Landmark Commission

AGENDA

APPLICATION FOR A CERTIFICATE OF APPROPRIATENESS FOR OUTDOOR SIDEWALK PATIO AT VITA SANDUSKY (256 COLUMBUS AVENUE)

APPLICATION FOR A CERTIFICATE OF APPROPRIATENESS FOR EXTERIOR ALTERATIONS ON THE FEICK BUILDING AT 158 E. MARKET ST.

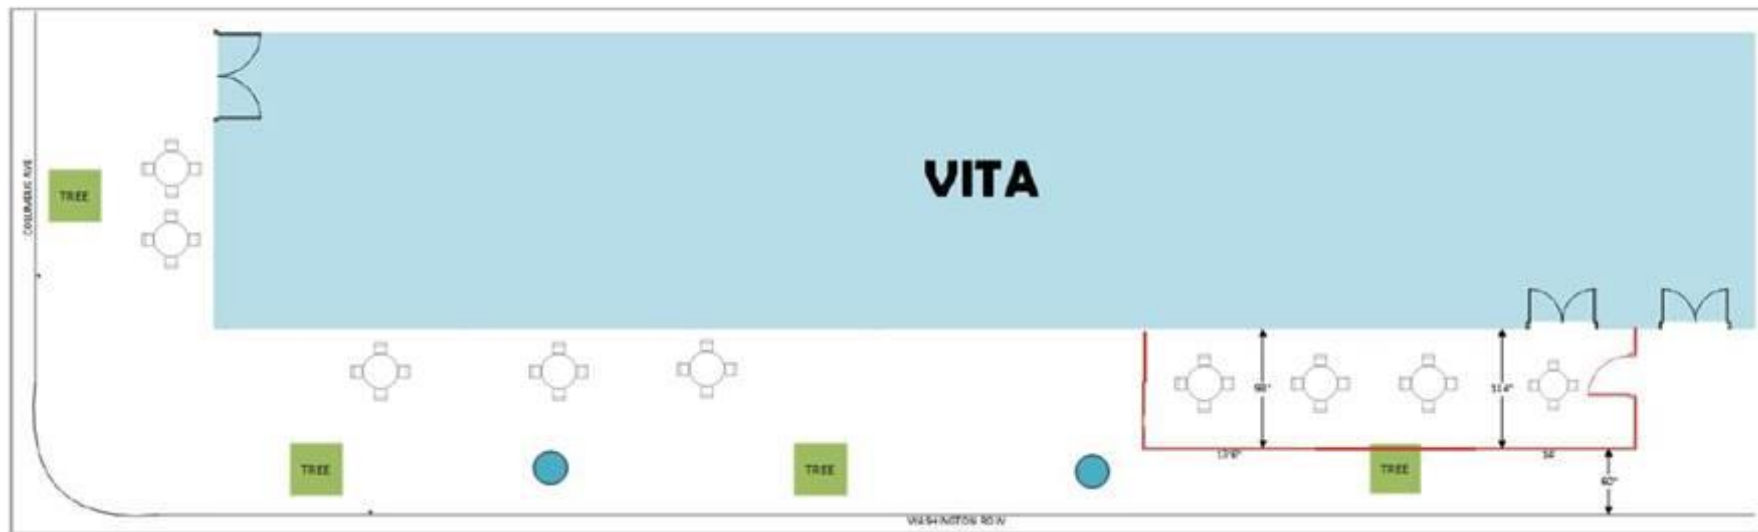
Updated 5/14/2020: The applicant has submitted a revised plan that has fencing along just a portion of Washington Row, leaving 5 feet of unobstructed sidewalk space. The specs for the fencing are included in this packet. The applicant will also be placing additional tables and chairs outside along the sidewalk, but without fencing. The Division of Engineering Services has approved this arrangement as a temporary seasonal encroachment.

Staff has worked with the Division of Engineering Services and the applicant, and recommends approval of the Certificate of Appropriateness for the outdoor dining fencing.

- Fencing extends from the Washington Row entrance about 30 feet to the west.
- At least 5 feet of clear sidewalk on the south side of the fencing.
- Additional tables and chairs could be placed next to building along Washington Row and Columbus Ave.
- Fencing would be removable and seasonal, and placement could be re-evaluated on yearly basis.
- Efforts are currently underway in the Ohio General Assembly regarding outdoor dining alcohol regulations, which could potentially allow for more flexibility in the near future.

Enlarged Plan and Elevation at Front Facade

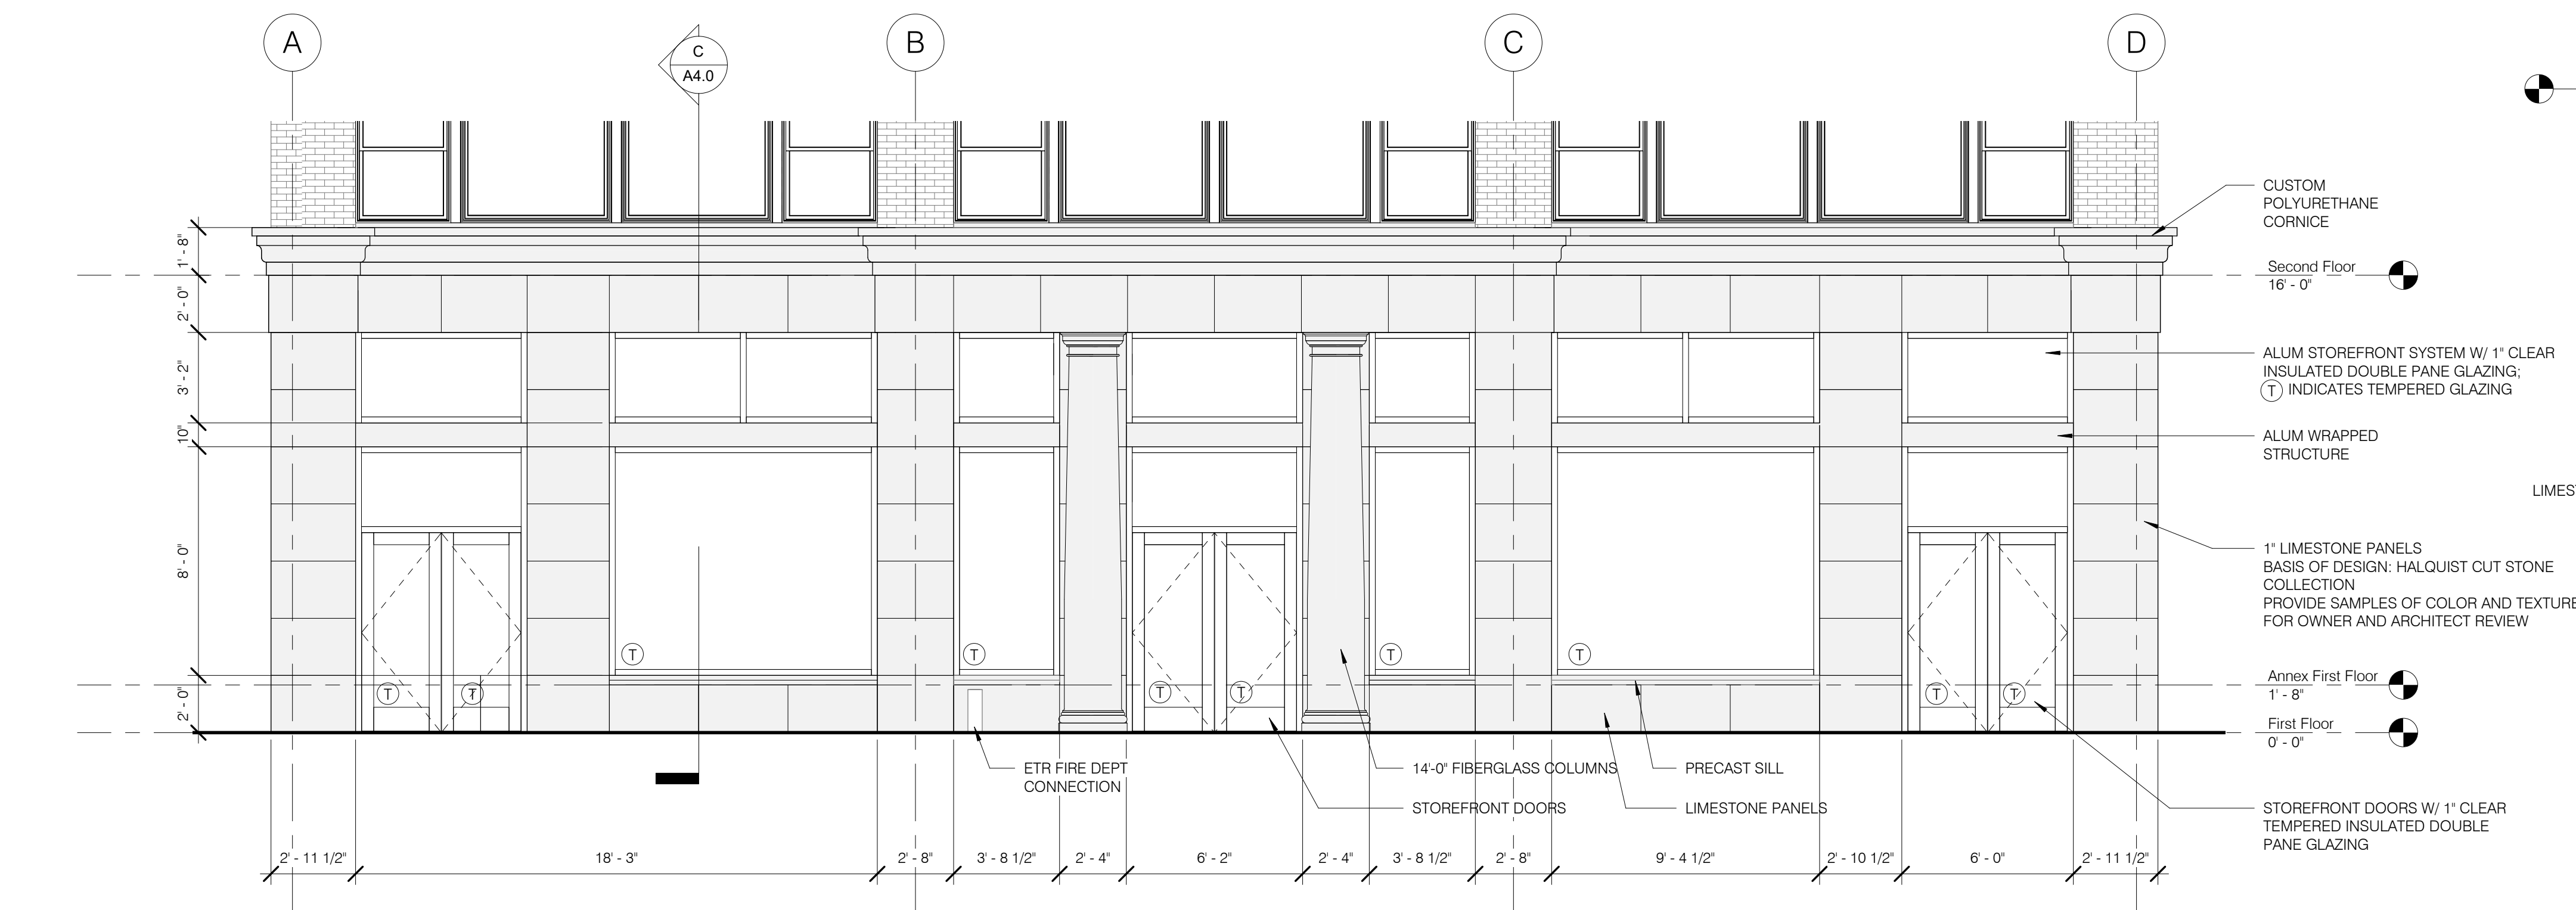
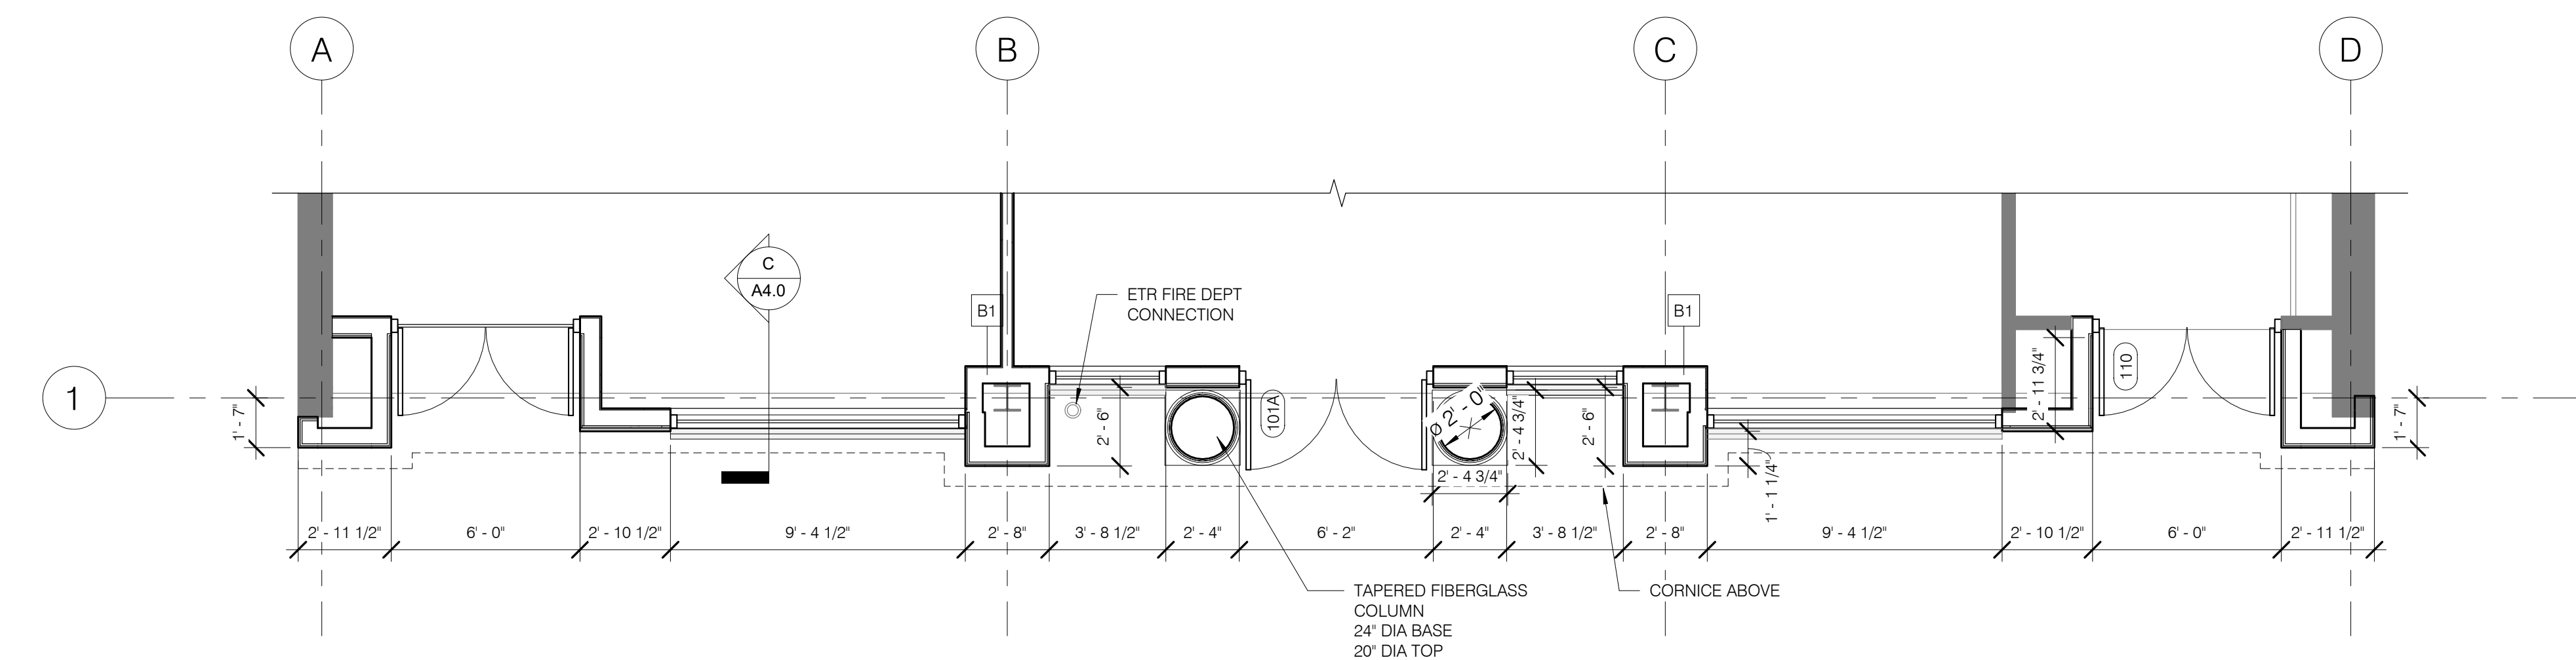
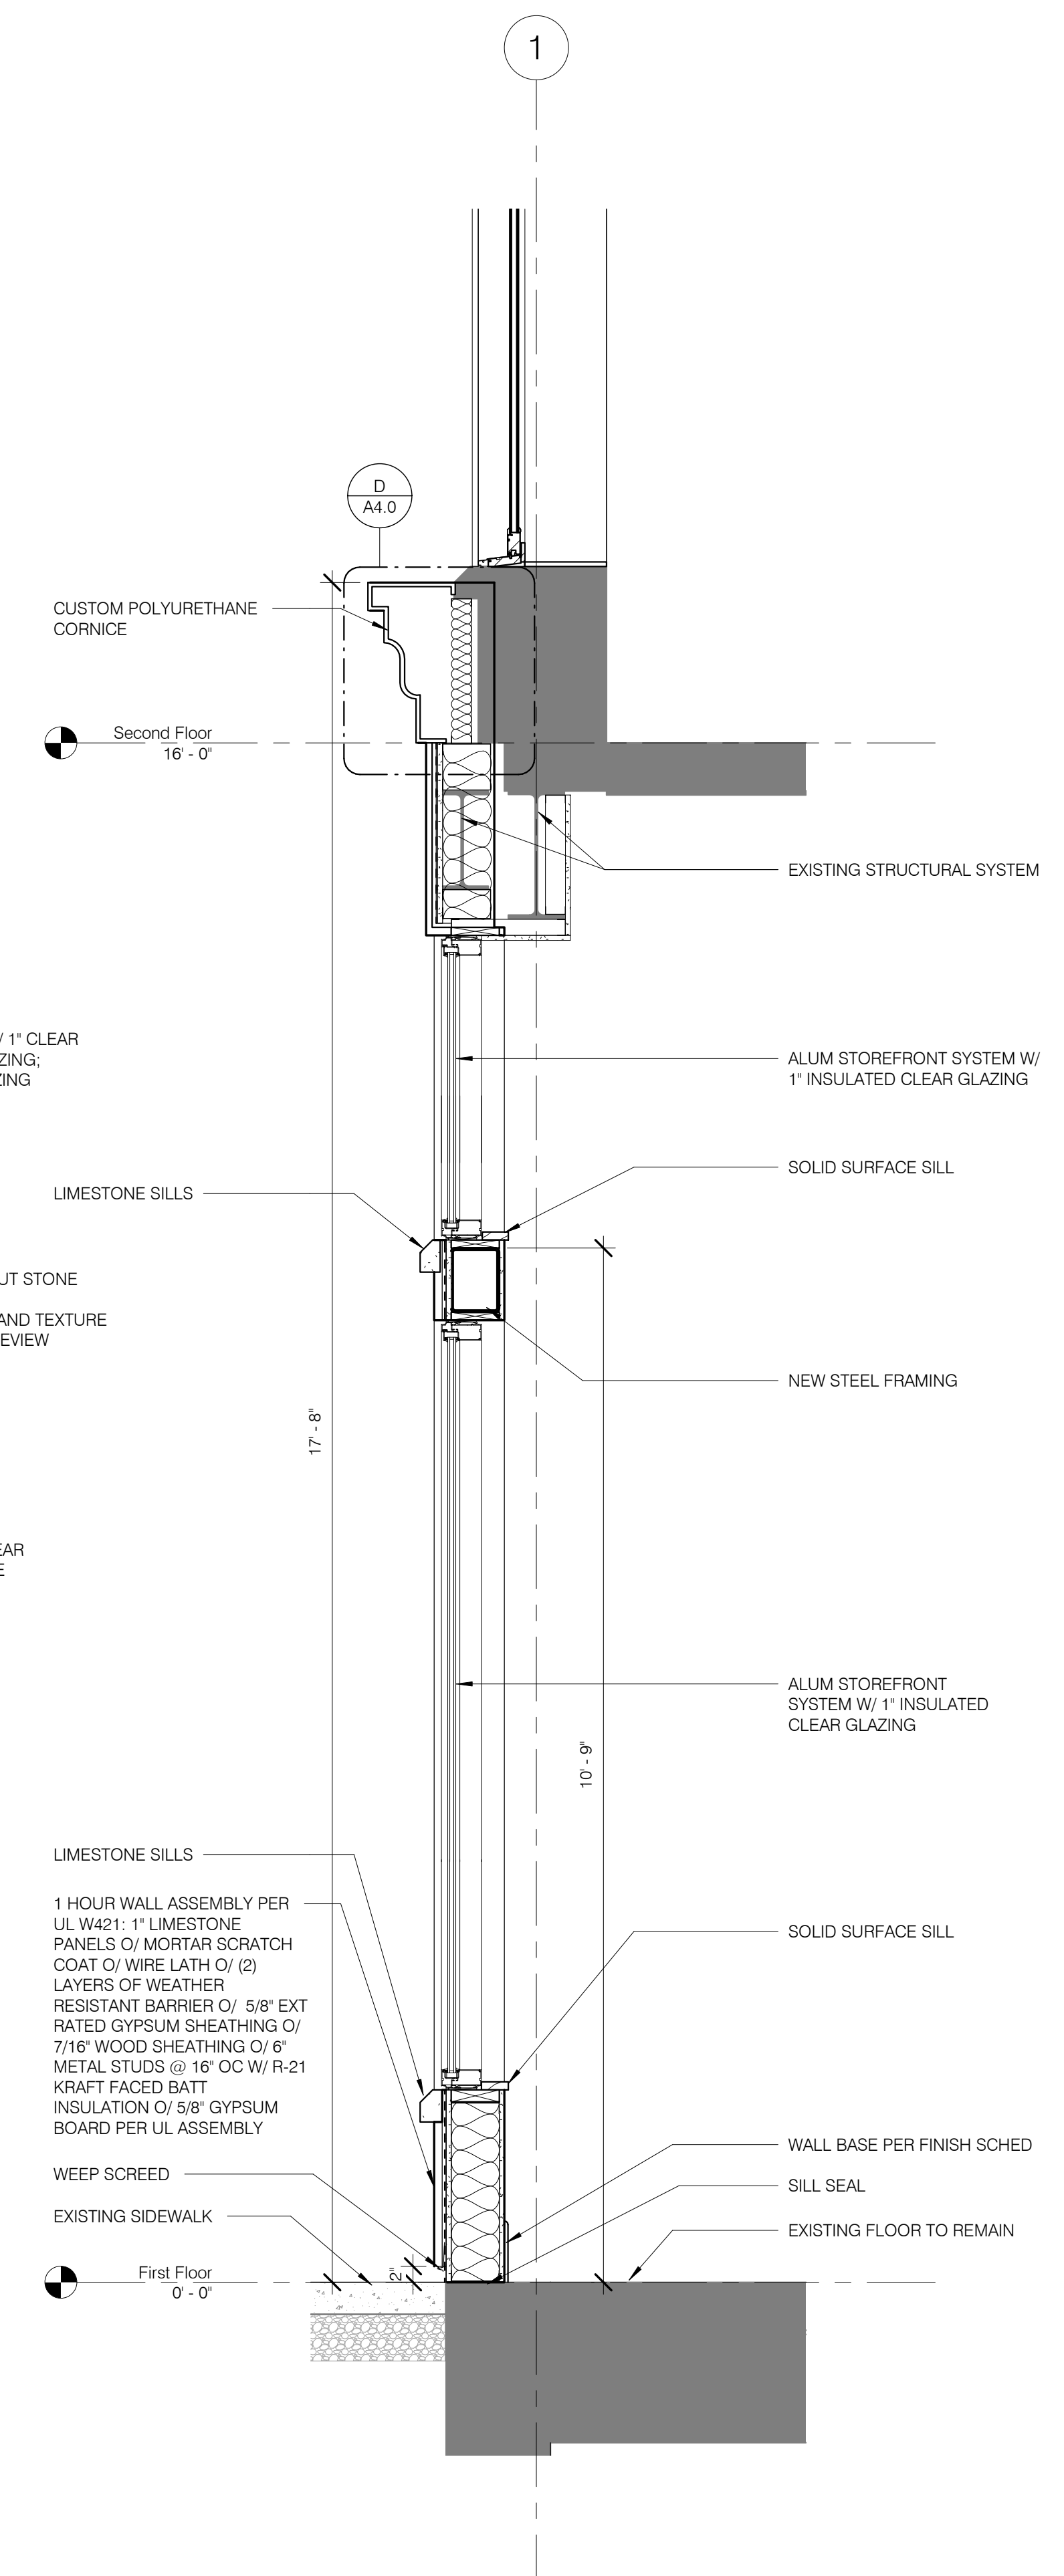
The applicant has provided a narrative describing the work to be done on the storefront façade and the window replacement. Staff believes the proposed new storefront is appropriate and is in line with the historic storefront. The most significant visual deviation from the historic storefront is that the new one would add an additional doorway on the far eastern side of the building. This is to accommodate the modern needs for the storefront space, and it also creates a visual symmetry that was not present in the historic storefront. The wall panels of the storefront will be 1" thick limestone panels and the columns and cornice will be molded millwork that will be painted to match the limestone. The storefront windows and doors will be made of aluminum and painted dark bronze. The Sandusky Preservation Design Guidelines do not speak specifically about standards for restoring historic storefronts when all the historic materials had been removed, as was the case here. The Guidelines simply say "it is sometimes best to leave the modern front than attempt a restoration." Staff believes this is a situation where restoration of the historic façade is in the best interest of the building, as the modern façade did not complement the rest of the historic nature of the building.

Staff believes that the proposed restoration of the Feick Building is important as it is one of the most notable buildings in the Downtown Sandusky Commercial Historic District and it also an individually listed landmark. Staff recommends granting the Certificate of Appropriateness for the restoration of the storefront, the replacement of the windows on the sides and rear of the buildings, as well as for the masonry work. Staff is awaiting additional information on the window replacement for the front side upper floors of the building, and should it be determined that the wooden windows warrant replacement, staff recommends approval of the applicant's proposed replacements.
